Limerick Generating Station, Units 1 and 2
Facility Operating License Nos. NPF-39 and NPF-85
NRC Docket Nos. 50-352 and 50-353

Subject: Response to Request for Additional Information Concerning Relief
Requests Associated with the Second Inservice Inspection (ISI) Interval

**Response to Request for Additional Information
Regarding Relief Requests Associated With the
Second Inservice Inspection Interval**

Limerick Generating Station, Units 1 and 2

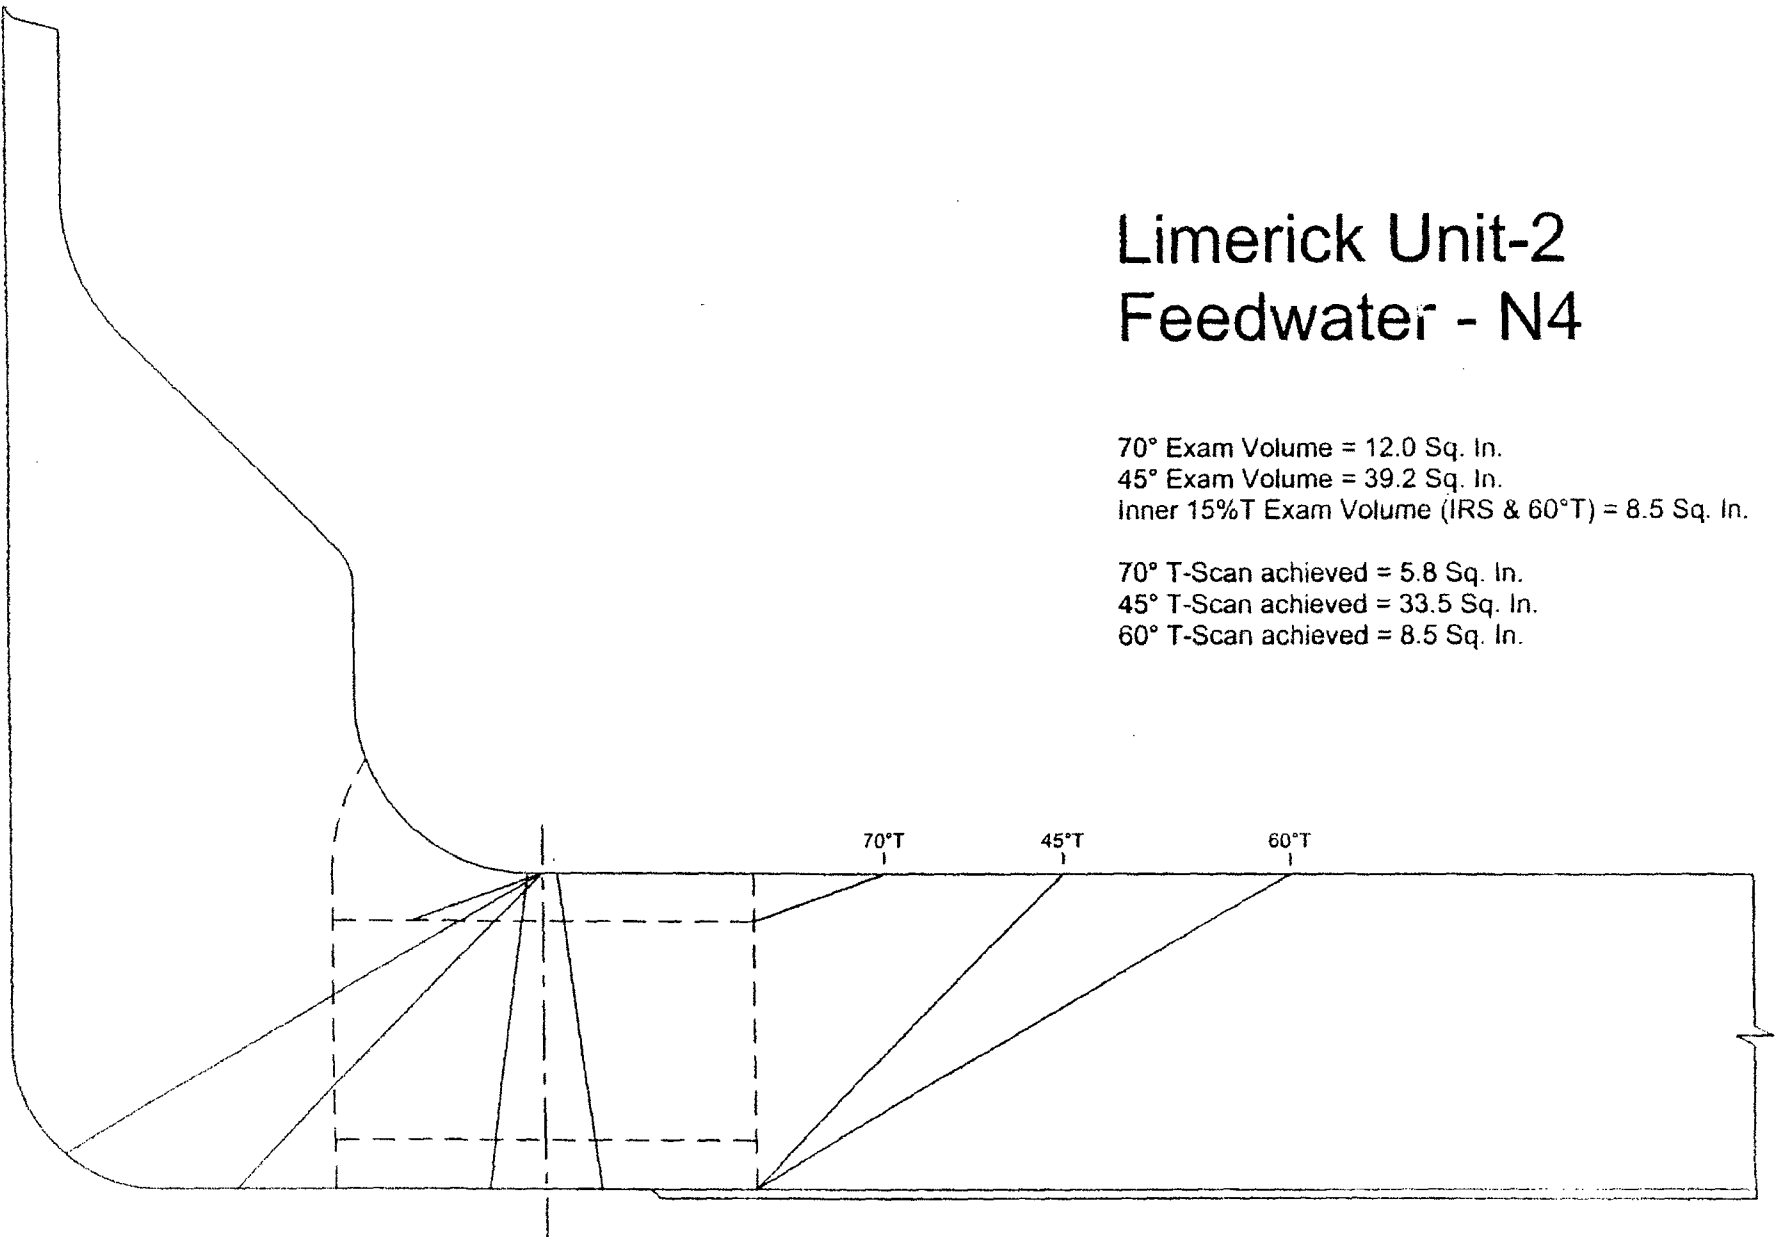
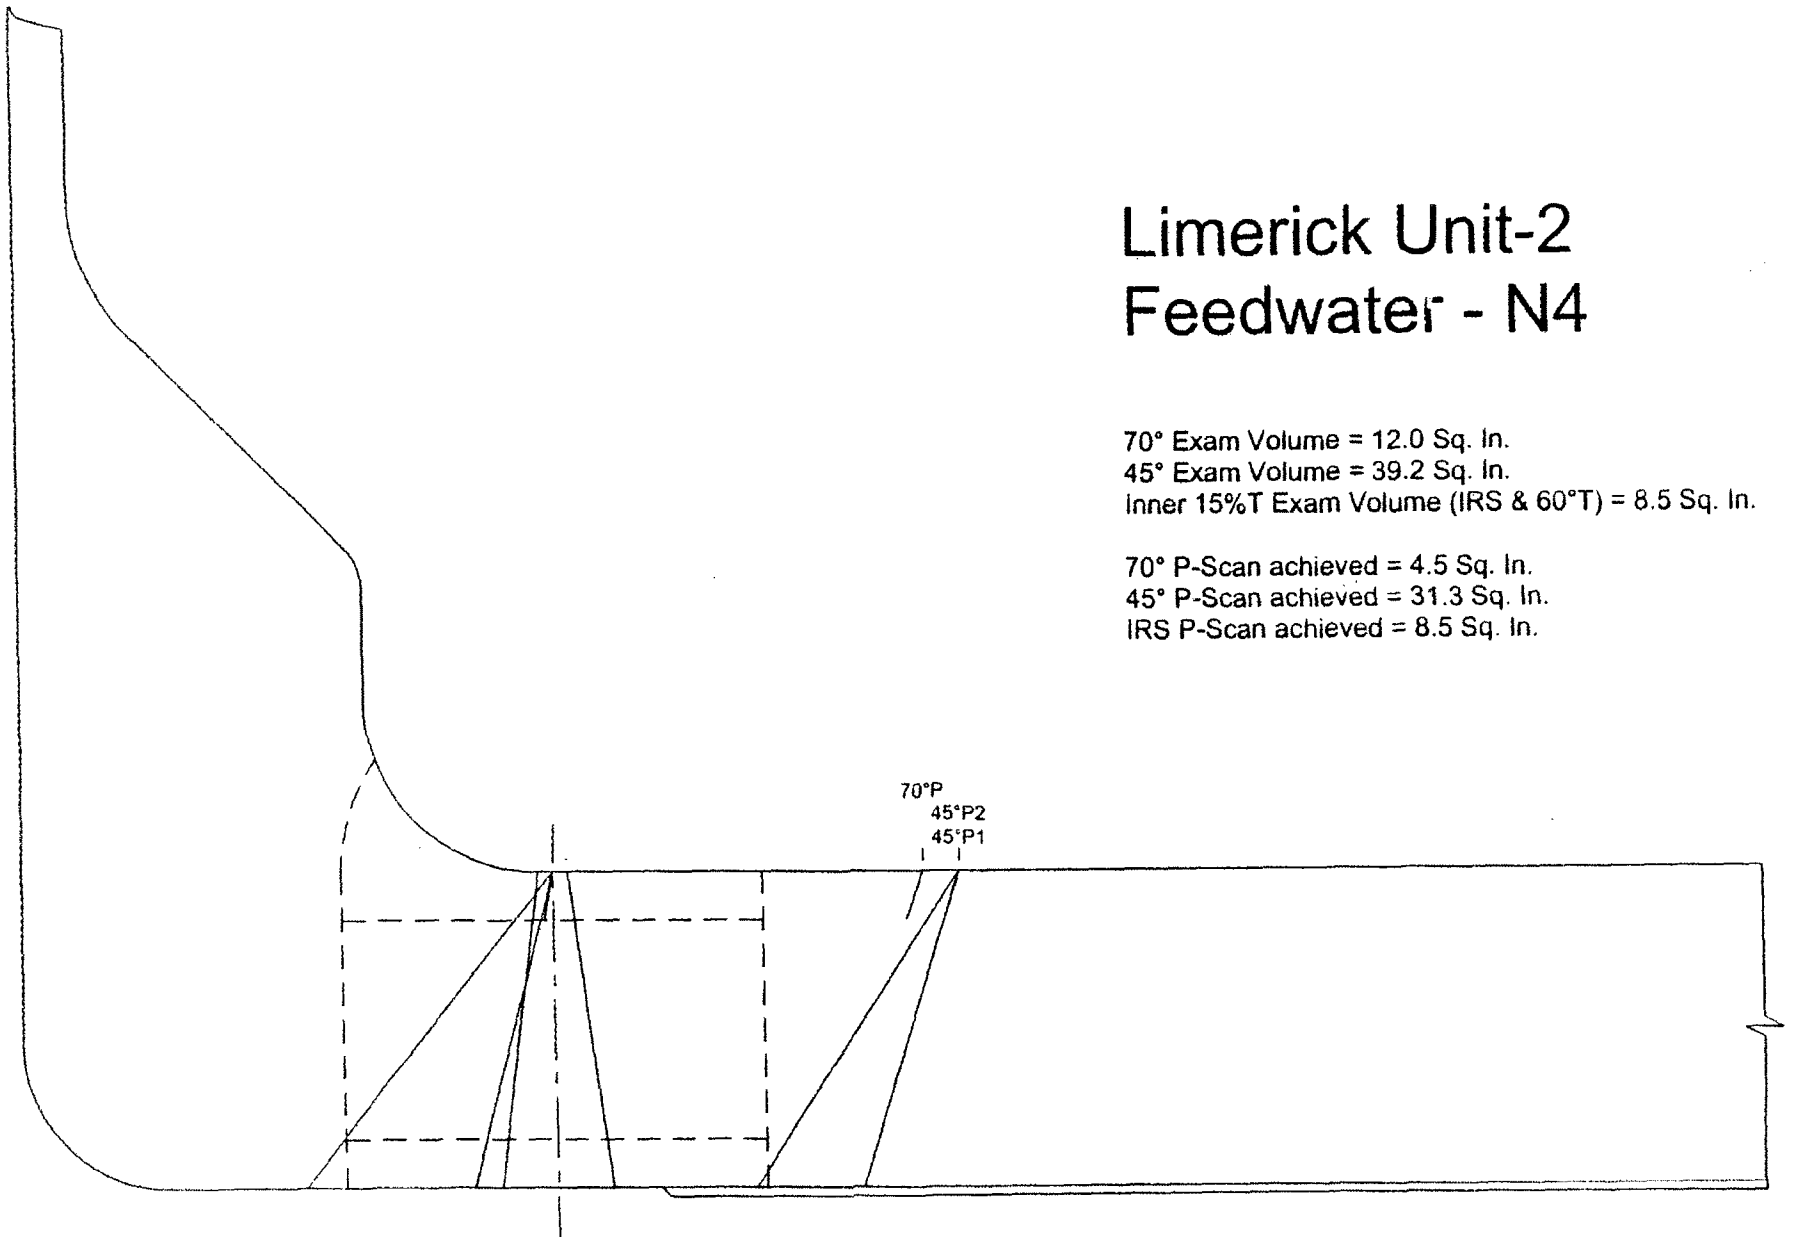
Comments: A - Examined 360°. Scanning limited due to nozzle configuration and N11B nozzle.

Unit 2 Vessel Nozzle and Weld Locations

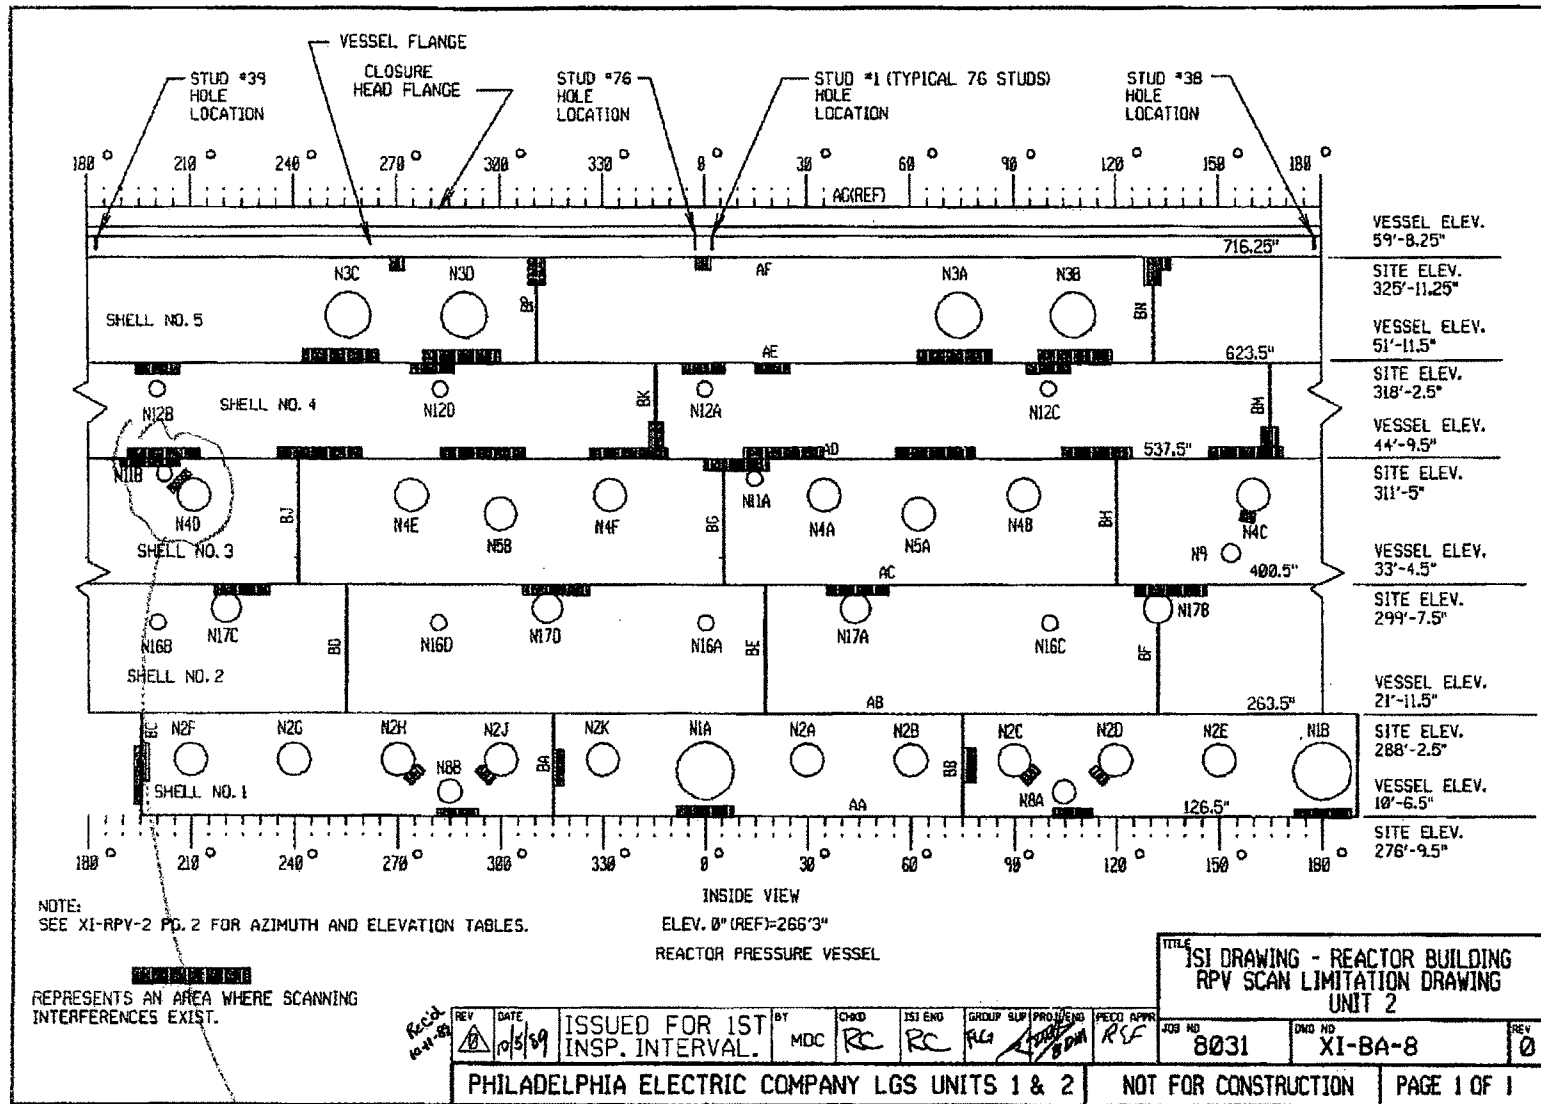
The location of the N11 nozzle
limits the examination of the
N14D nozzle.

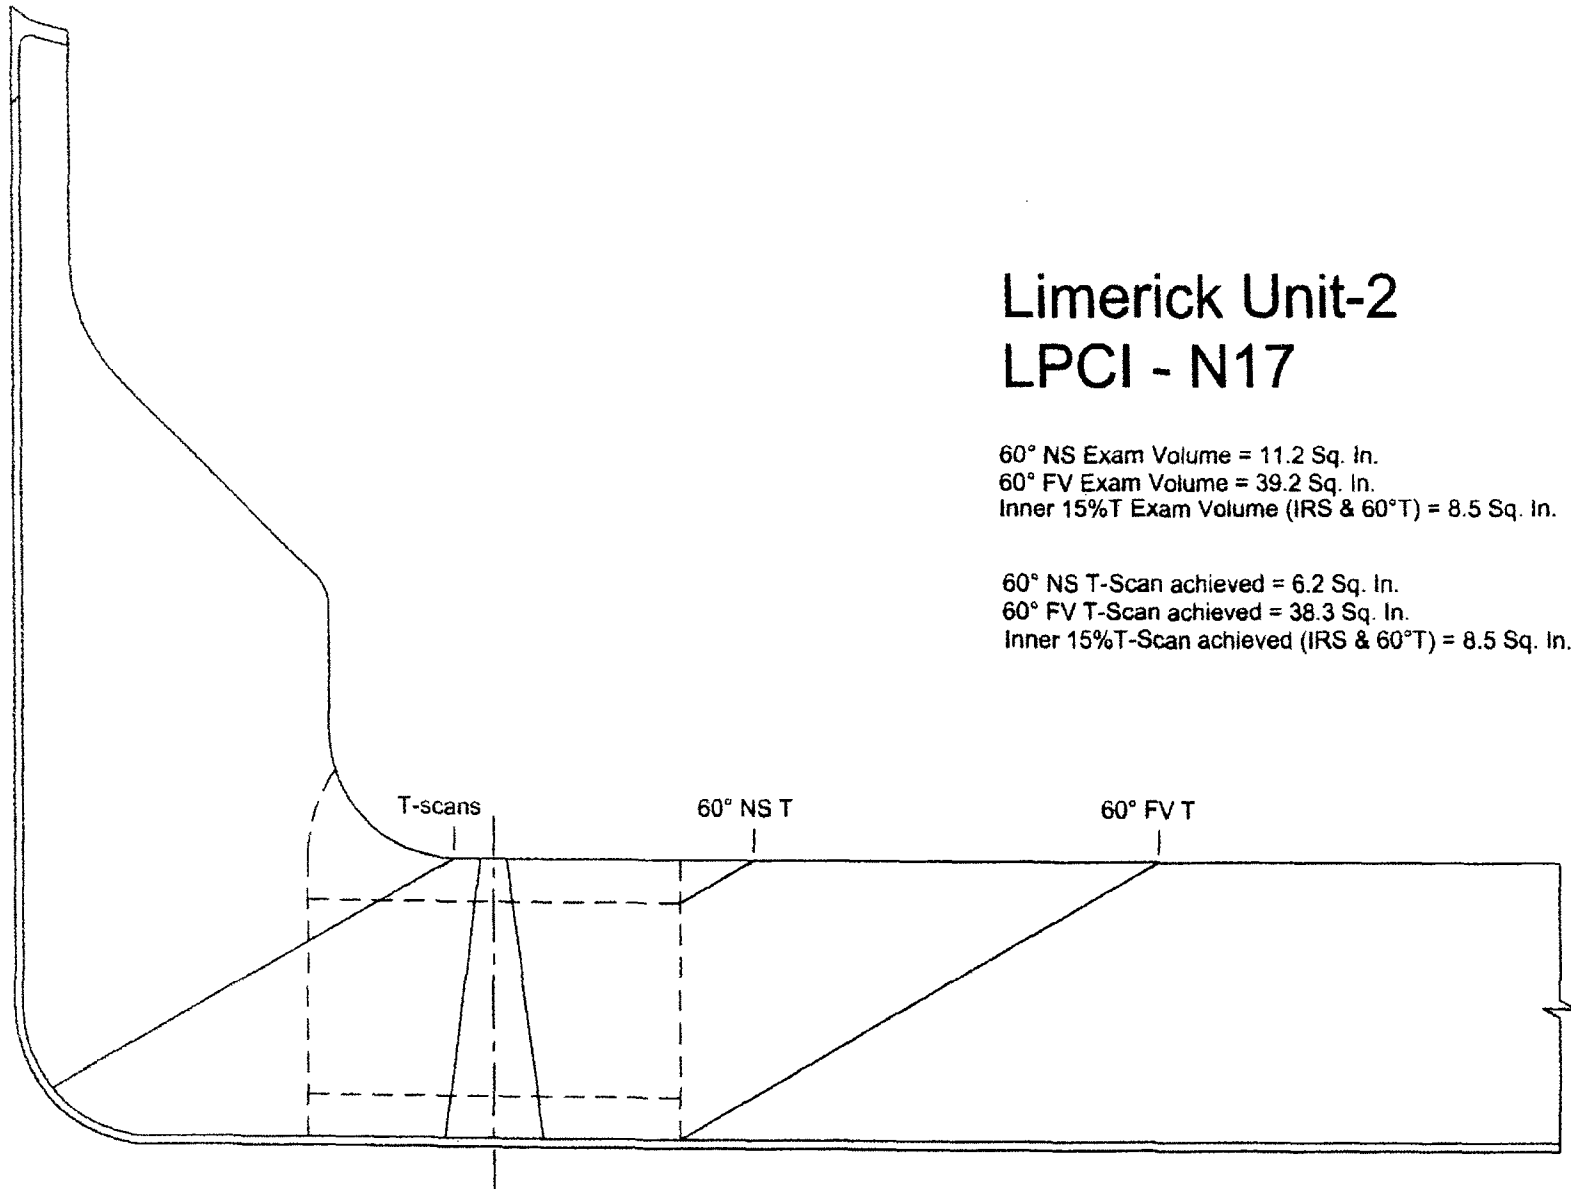
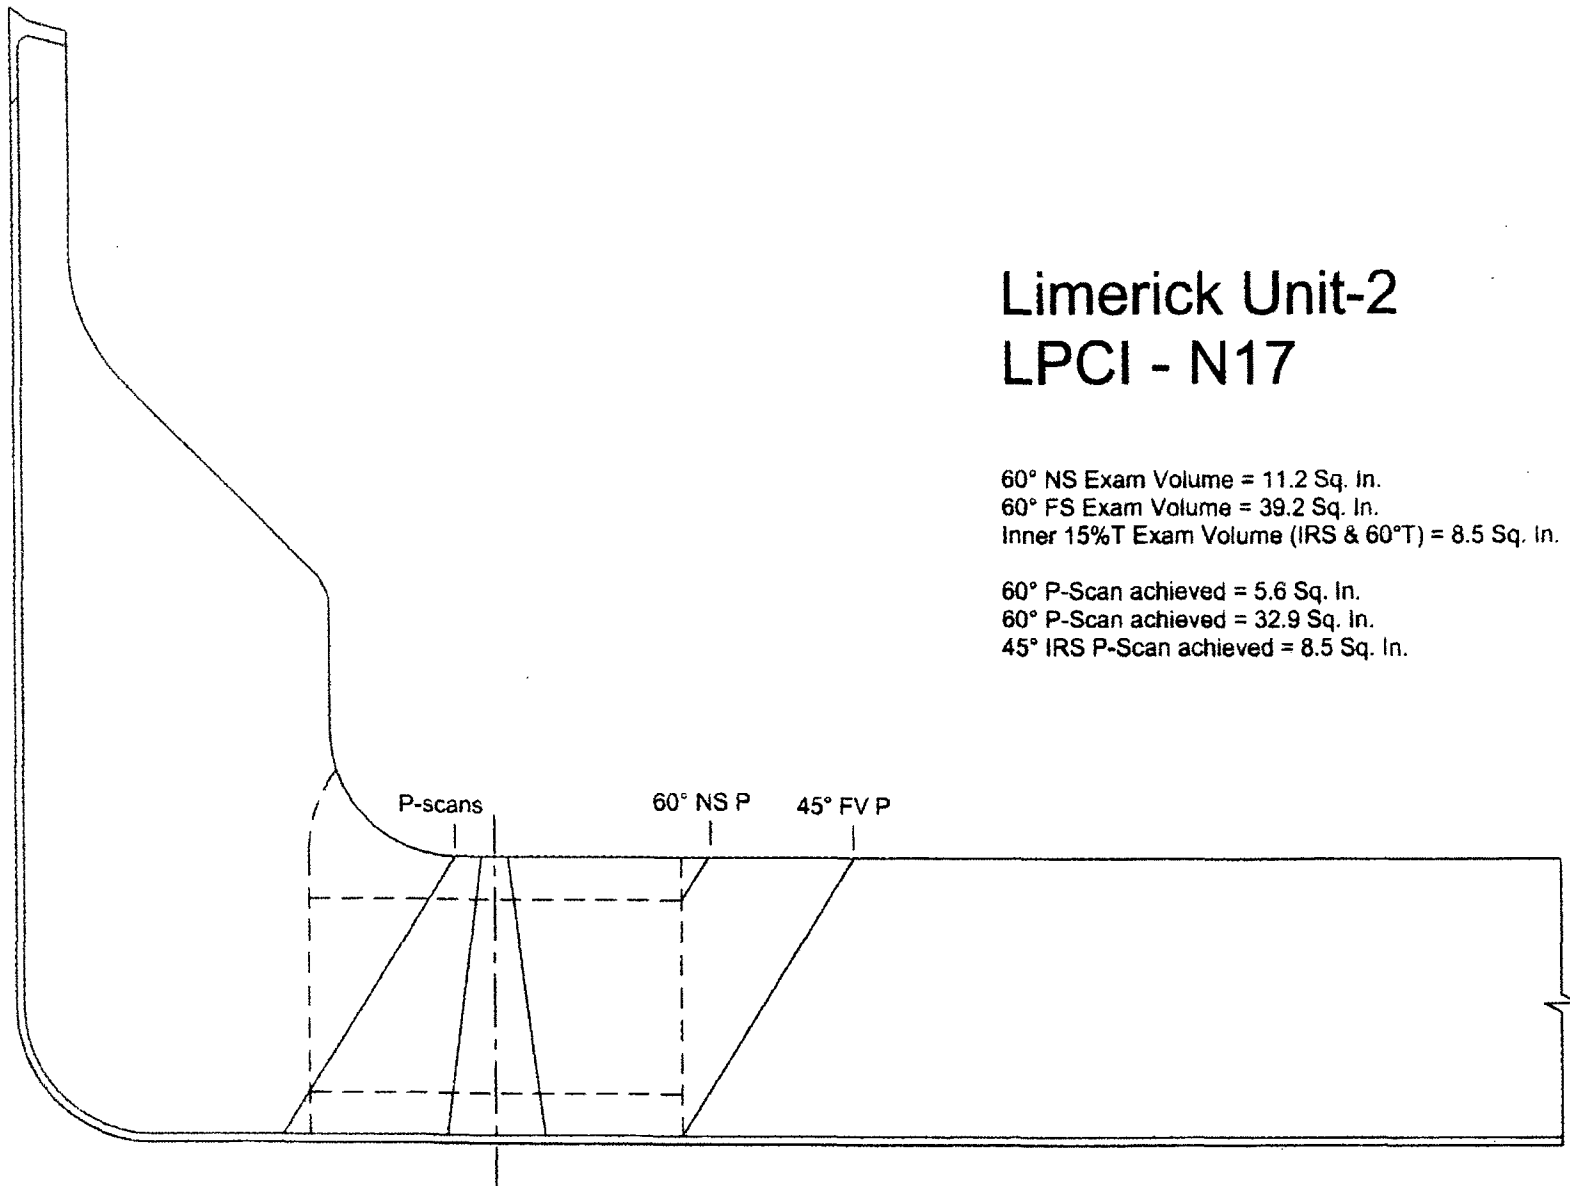
The completed examination was limited to 81.2% Code required coverage due to the design of the reactor vessel nozzle. The following drawings contain the limitations. No unacceptable indications were noted. A system pressure test was also completed with no unacceptable indications observed.
